Access Compliance Report

Public Rights-of-Way

(Pedestrian Signals)

Intersection ID: N/A	Main Street:	Cross Street: N/A	Location: N/A
ADA ID: 25A465EE0185	Signal Type: One Push Button-APS	Overall Compliance: No	Severity Score: BTN 1: N/A BTN 2: N/A No BTN: N/A
Codes/Mitigation Info/Possible Solution		Field Measurements/Component Compliance

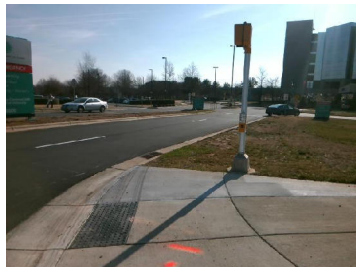
Surveyor Notes: N/A

PROW/ADA: TMUTCD 4e.08, R404.2, R404.7.2, R209.1, MUTCD 4e.10

Possible Solutions: Replace Signal Push Button With APS Button on New Post. Remove & Relocate Sign.
